Project: PRA-ROCR 10(5)
The purpose of this Amendment is to:

Amendment No. 0002
Project PRA-ROCR 10(5)
Rock Creek Park
Solicitation: DTFH71-16-R-00001

Project Name: Beach Drive from Rock Creek Parkway to Maryland State Line

AMENDMENT NO. 2 ◇1	PMIS NO.	NPS NO.	STATE	PROJECT	SHEET NO.
	044965	821 / 100425	DC	PRA-ROCR 10(5)	D26

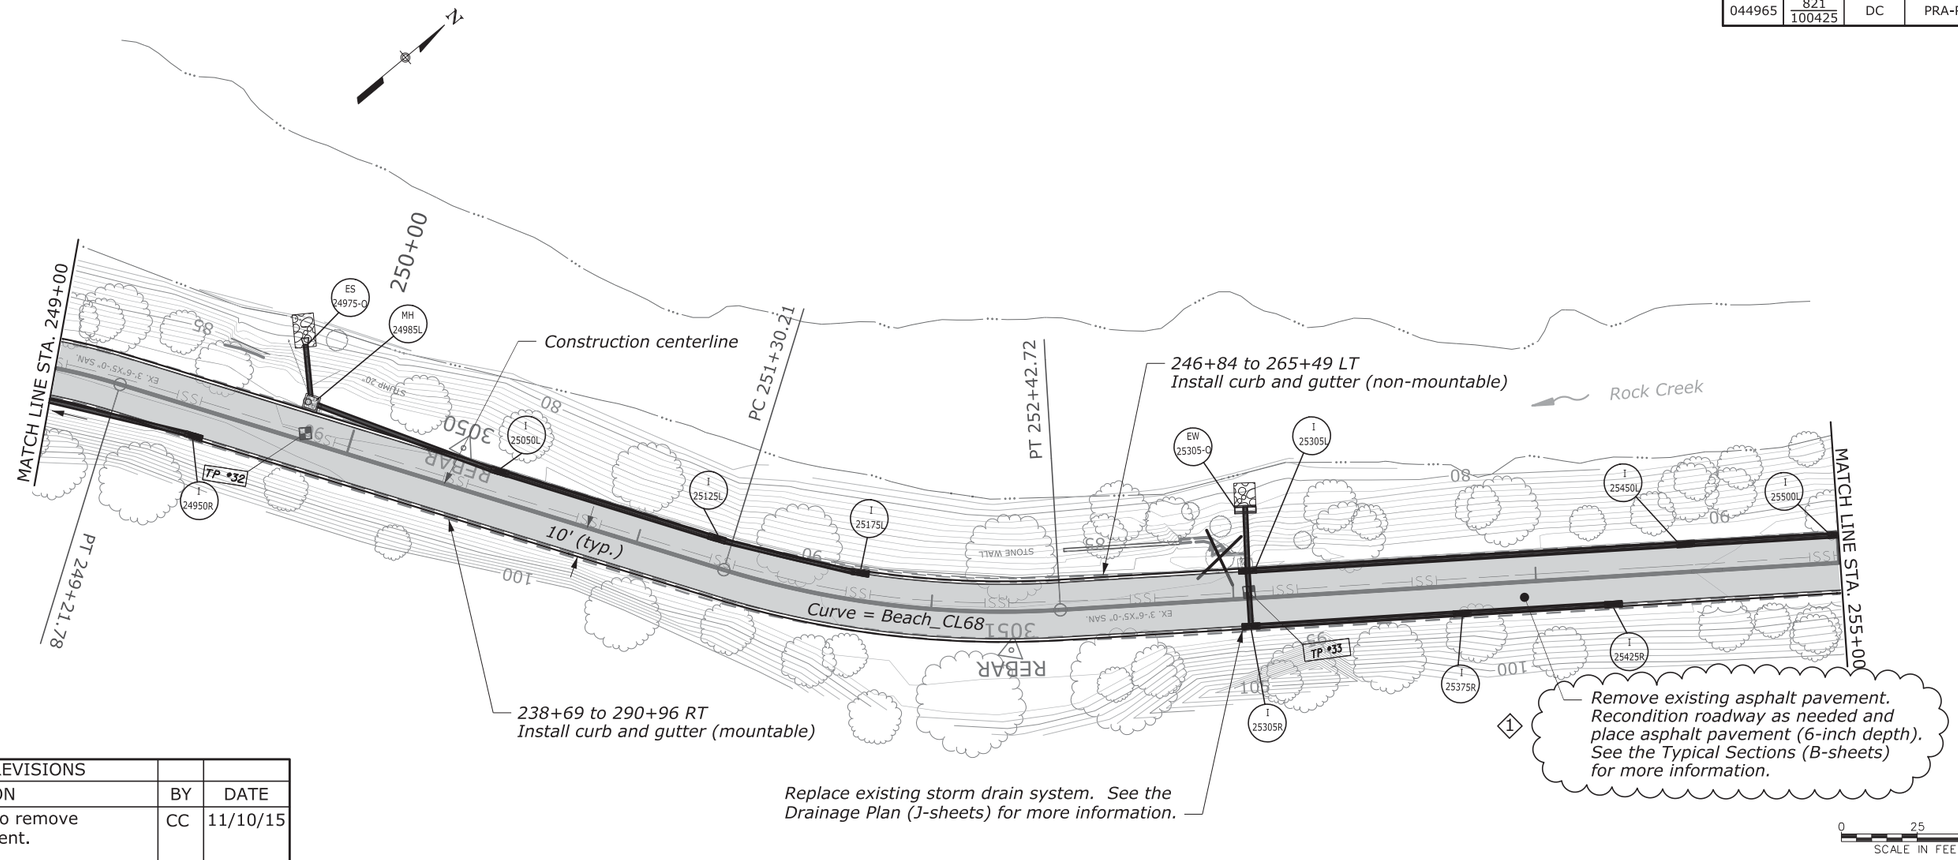
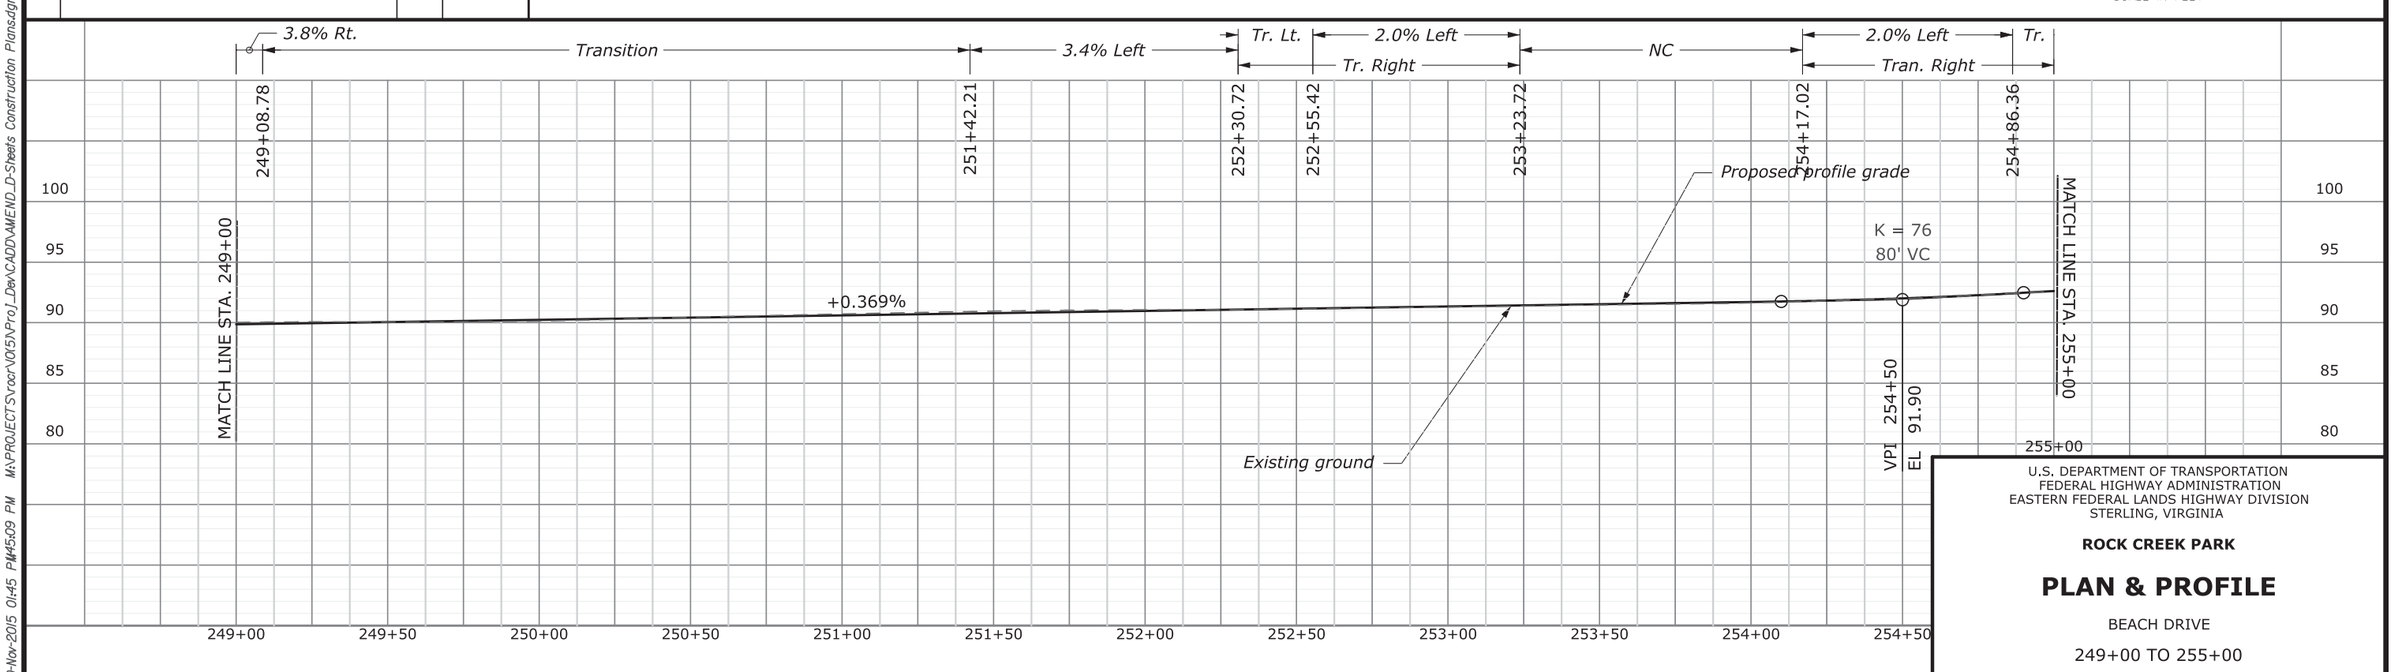
REVISIONS			
NO.	DESCRIPTION	BY	DATE
◇1	Revised the callout to remove the milling requirement.	CC	11/10/15

AMENDMENT NO. 2 ◇1	PMIS NO.	NPS NO.	STATE	PROJECT	SHEET NO.
	044965	821 / 100425	DC	PRA-ROCR 10(5)	D27

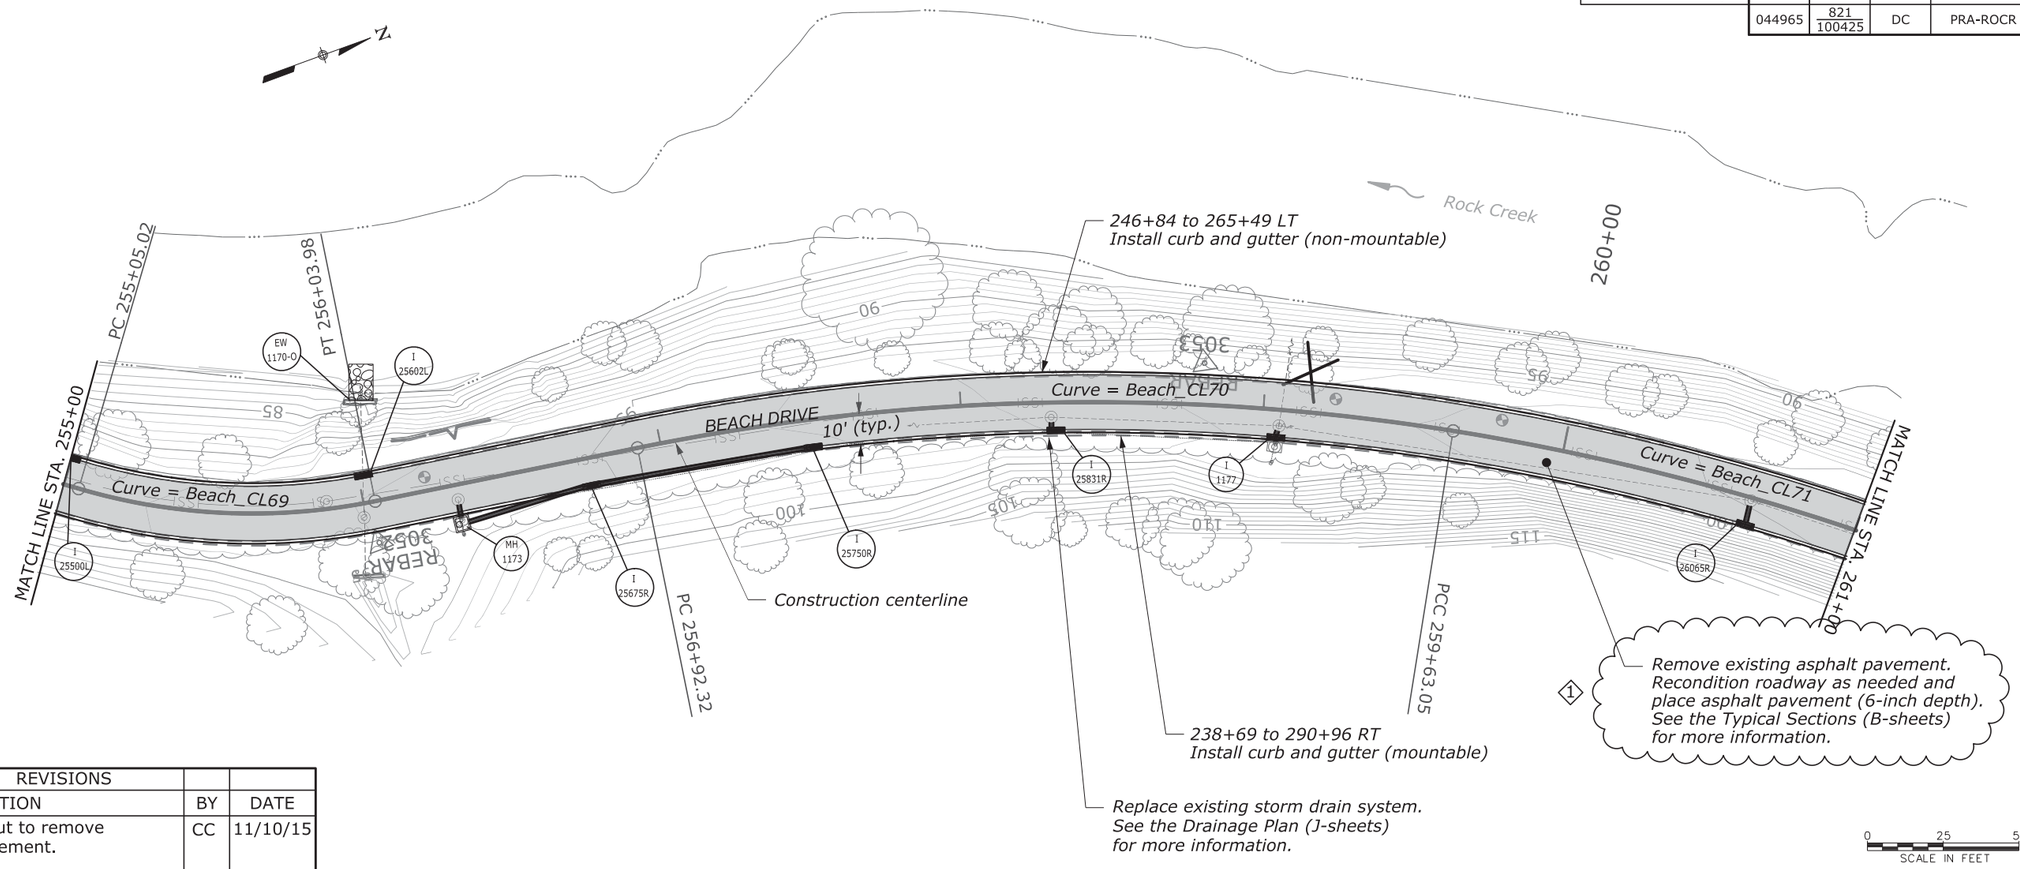
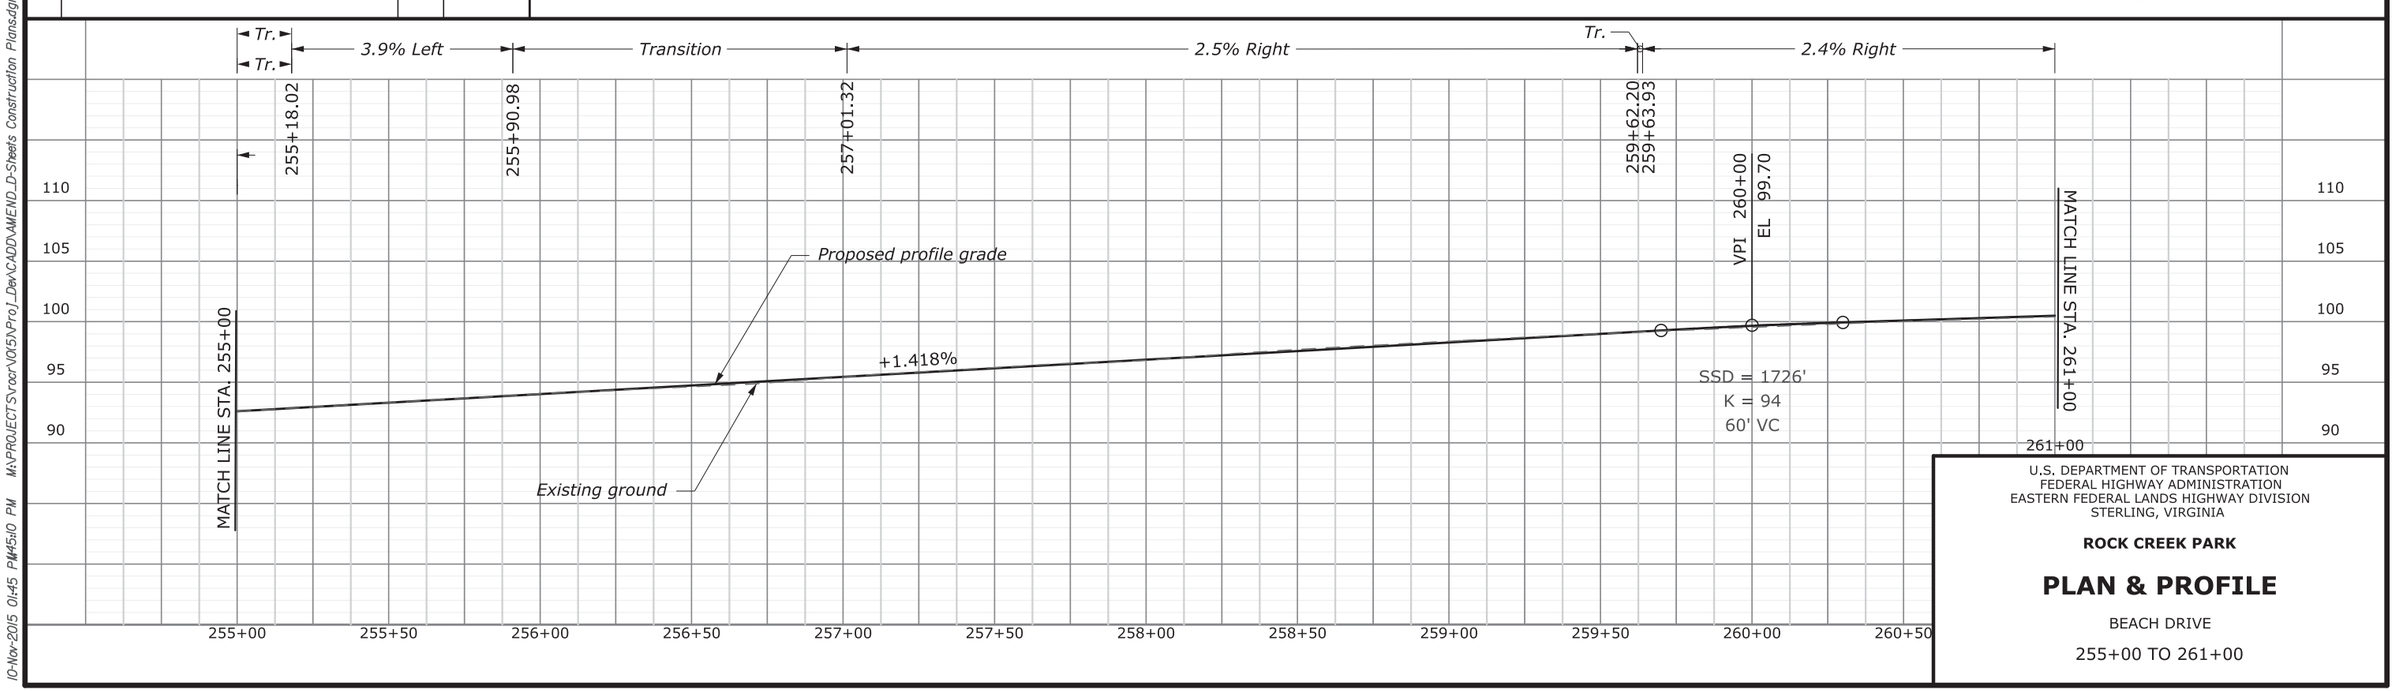
REVISIONS			
NO.	DESCRIPTION	BY	DATE
◇1	Revised the callout to remove the milling requirement.	CC	11/10/15

AMENDMENT NO. 2 ◇1	PMIS NO.	NPS NO.	STATE	PROJECT	SHEET NO.
	044965	821 / 100425	DC	PRA-ROCR 10(5)	D28

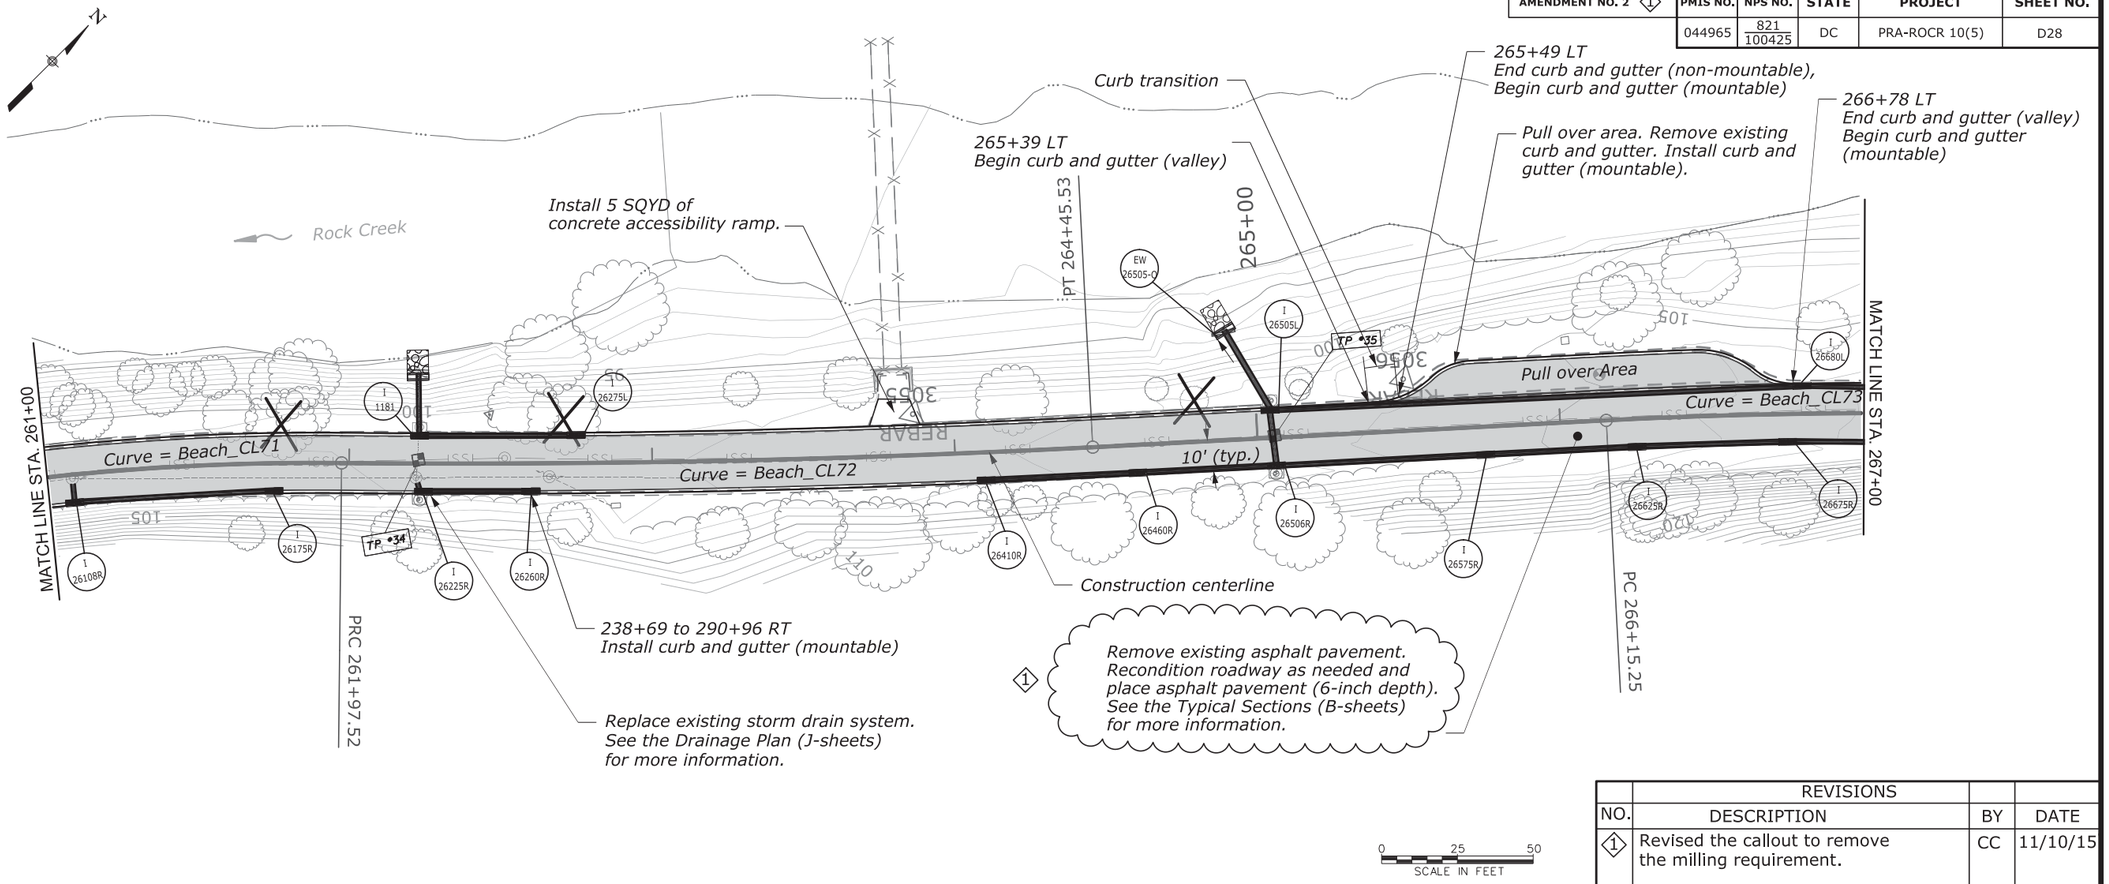
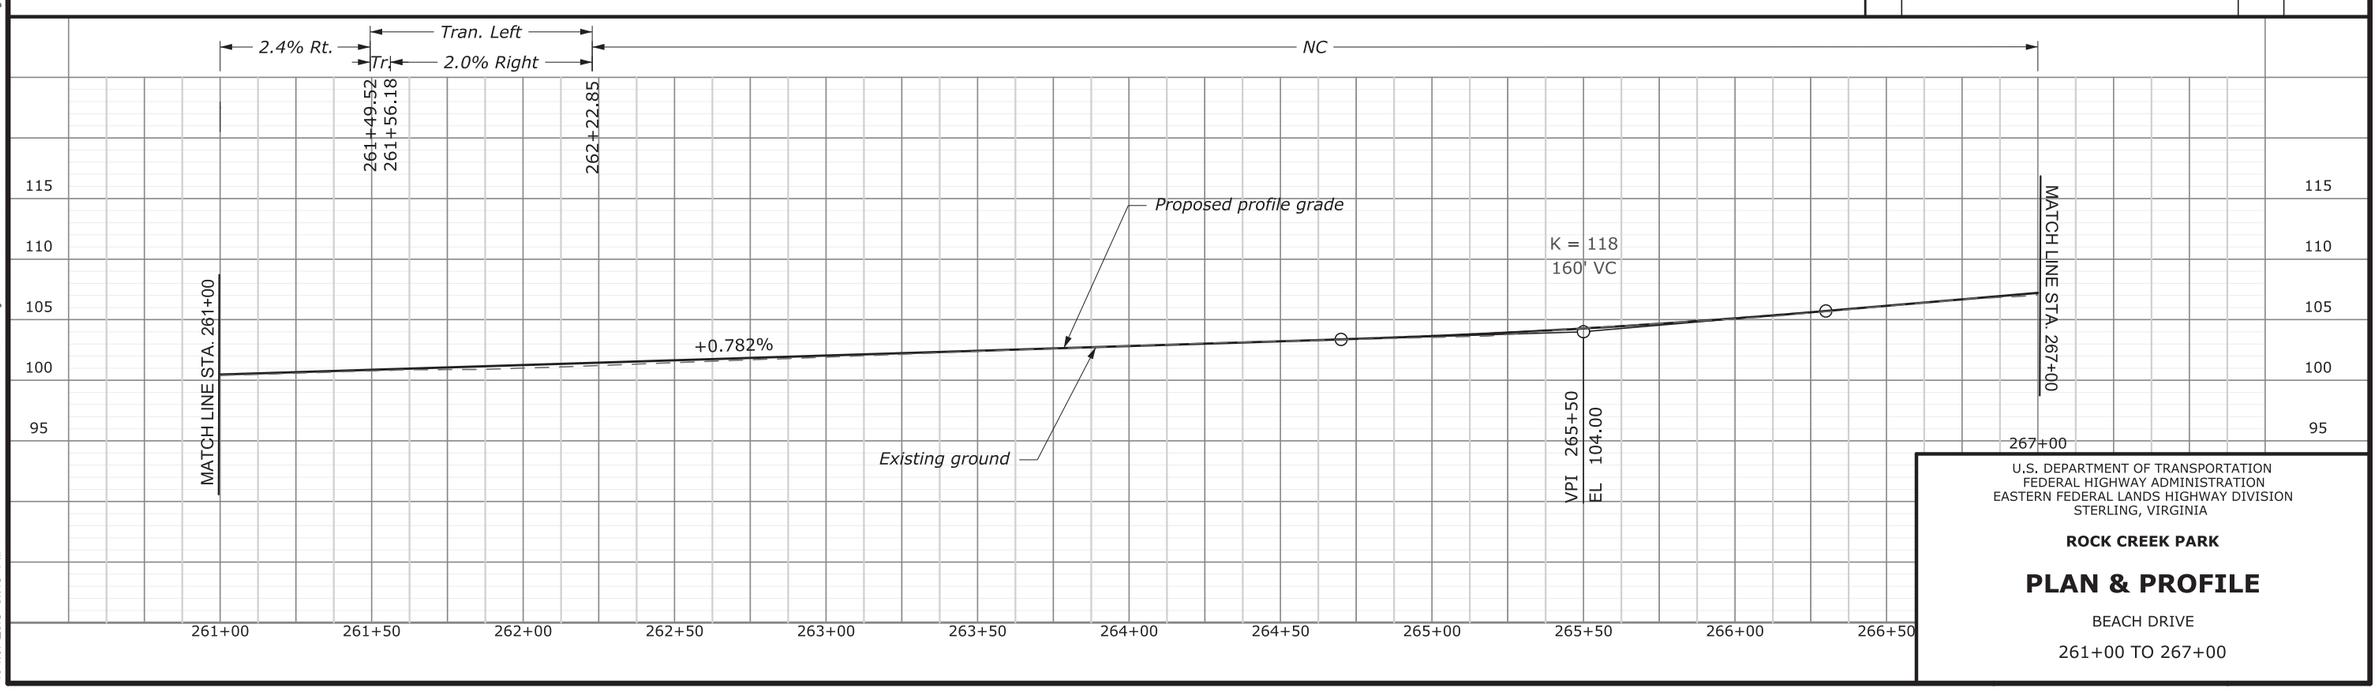
REVISIONS			
NO.	DESCRIPTION	BY	DATE
◇1	Revised the callout to remove the milling requirement.	CC	11/10/15
